CALIFORNIA COASTAL COMMISSION

Consistency determination number:	CD-021-03
Filed:	3/18/2003
60th day:	5/17/2003
75th day extended to:	11/15/2003
CCC objection:	11/7/2003
Staff:	D. Carl
Staff report prepared:	12/18/2003
Hearing date:	1/14/2004
Hearing item number:	W9a

FEDERAL CONSISTENCY DETERMINATION – PROPOSED FINDINGS

Federal agency..... **United States Army Corps of Engineers (Local Project Sponsor: Santa Cruz County Redevelopment Agency)**

FIGURE 2-5a

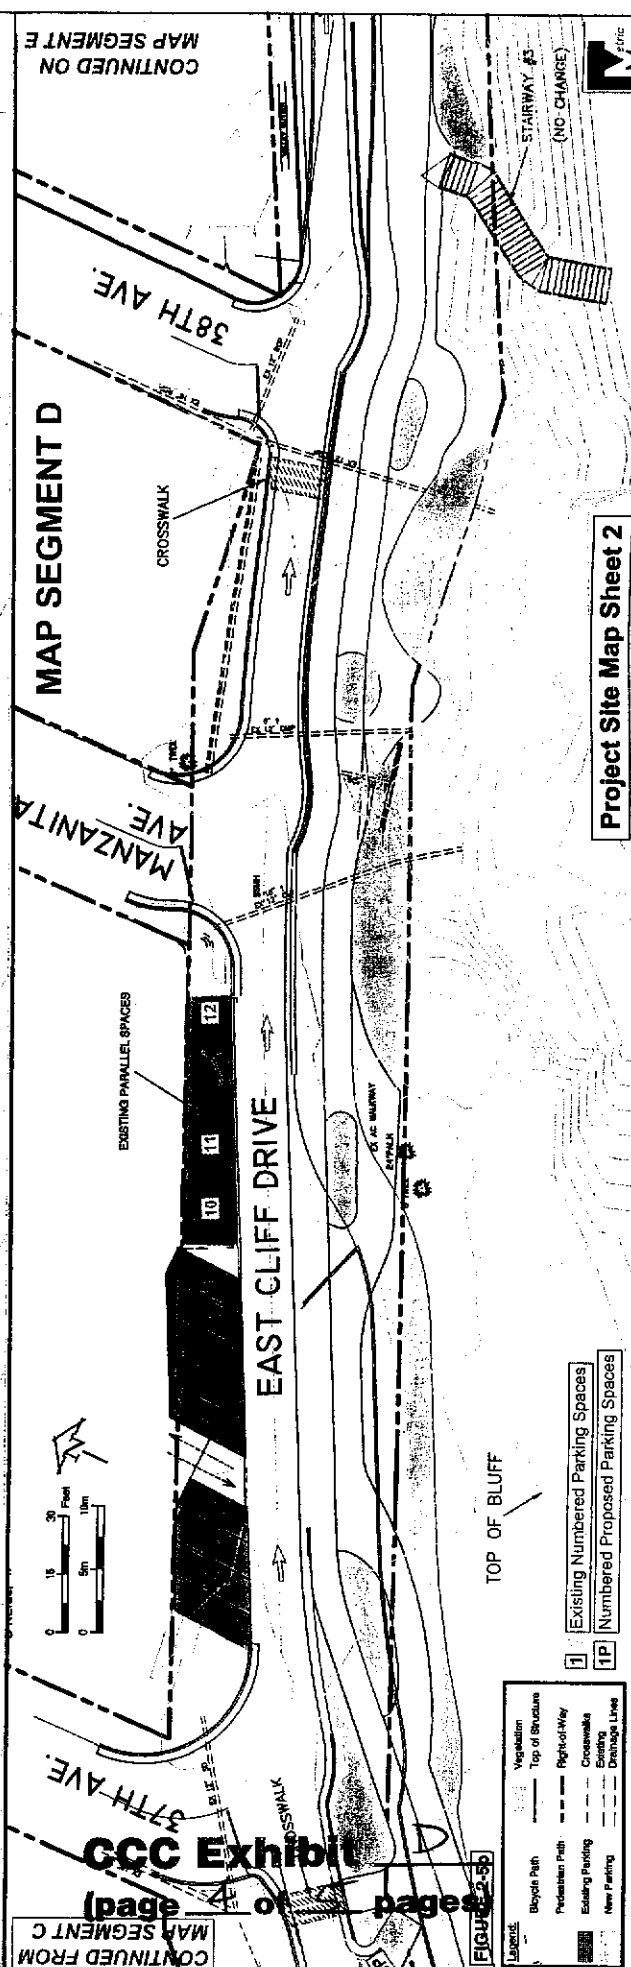
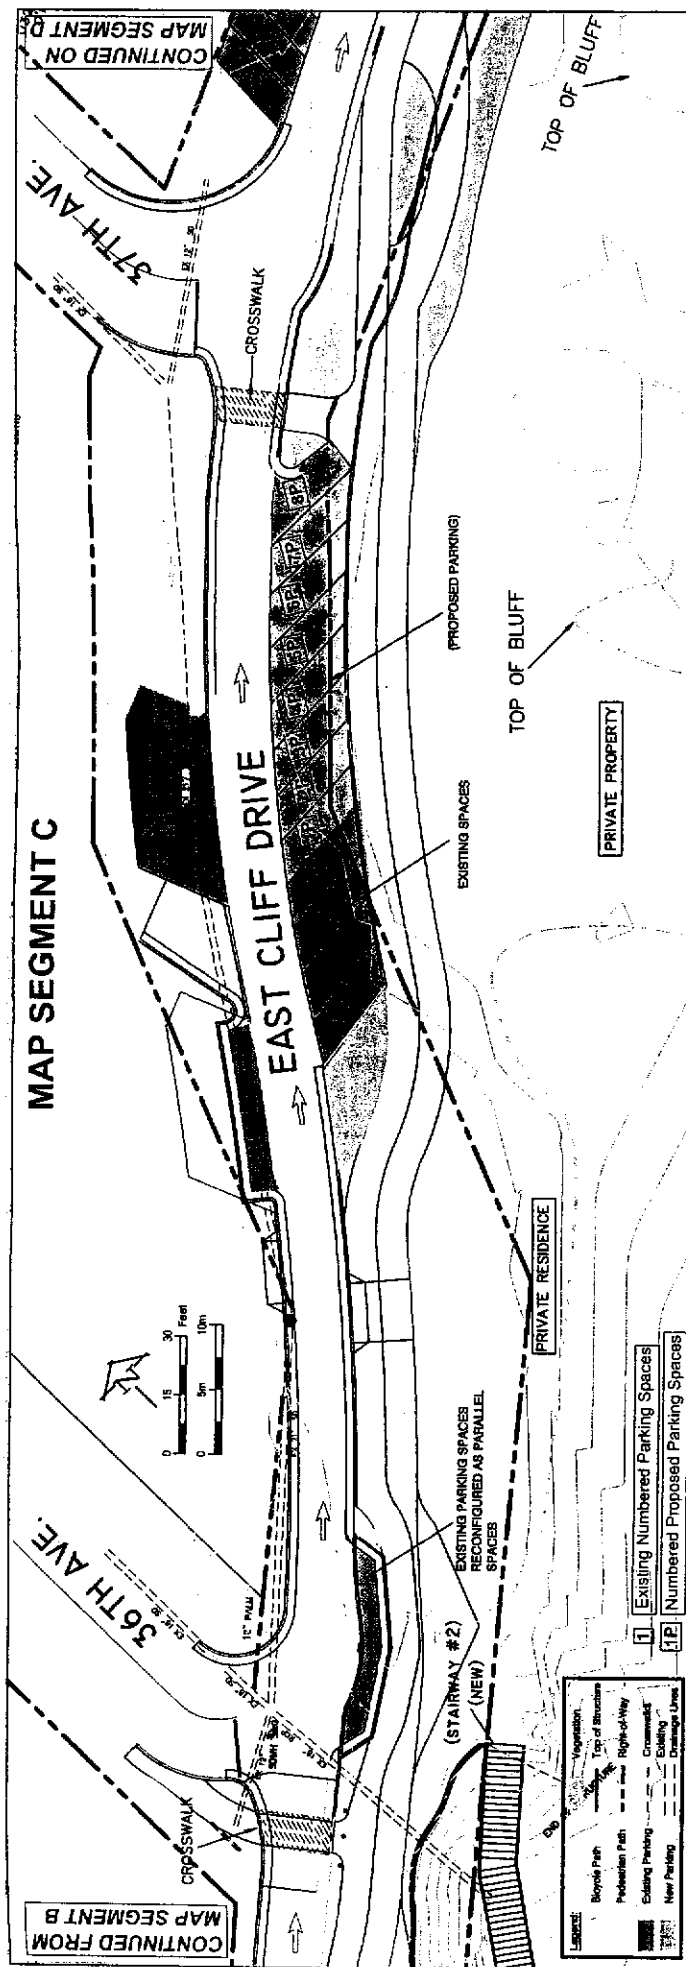
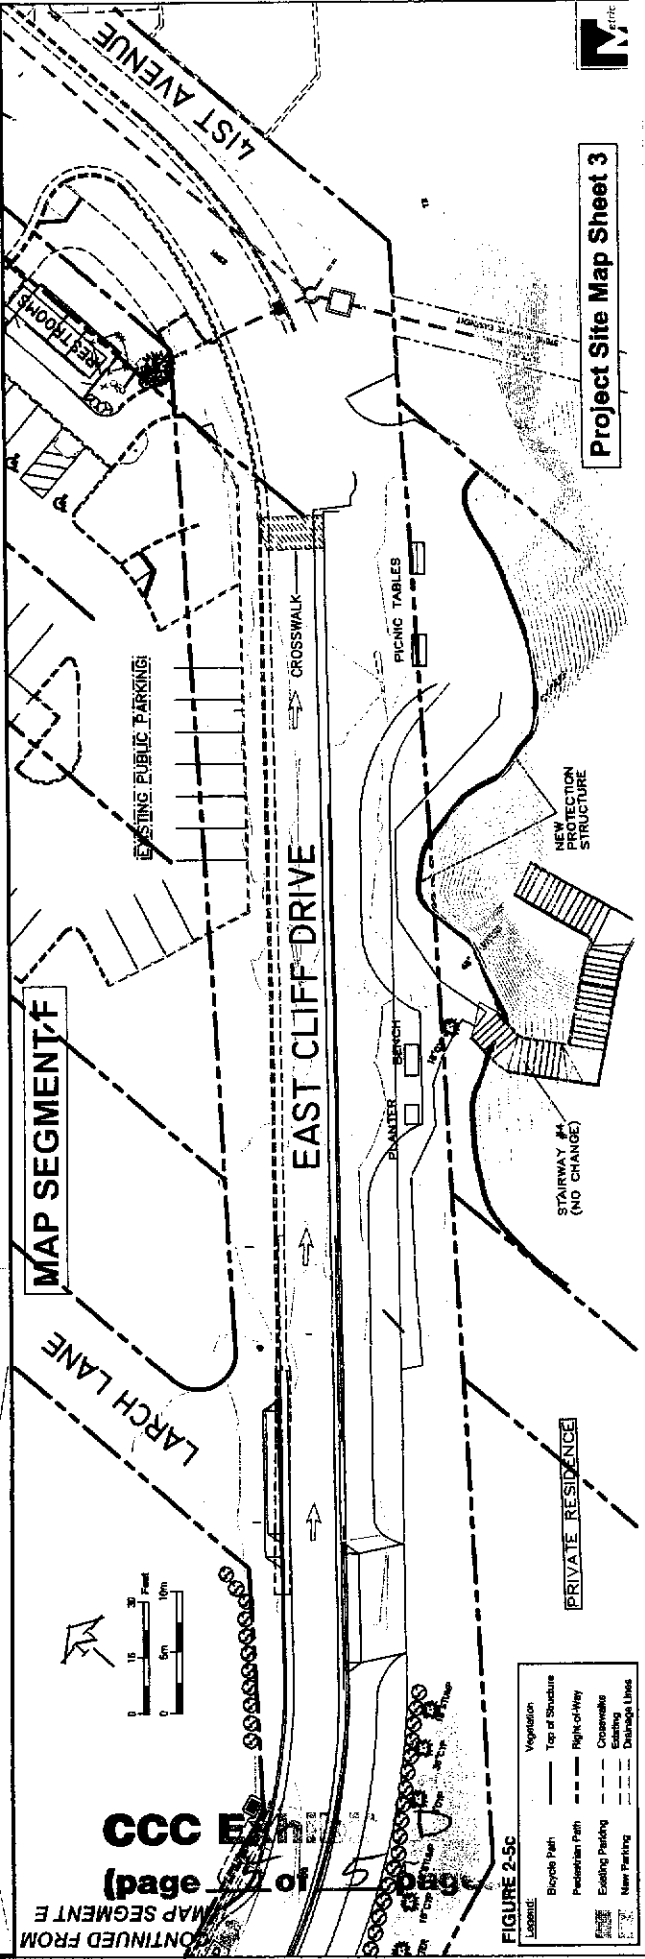
- (34) Figures 2-5a, b, and c lack a scale from which to measure. Please add a scale in feet (metric alone is insufficient).
- (35) The DEIS/DEIR dismisses under grounding utility lines due to expense, but it does not provide any cost figures. Please provide cost estimates for under grounding overhead utility lines along East Cliff Drive from 32nd through 41st Avenues.
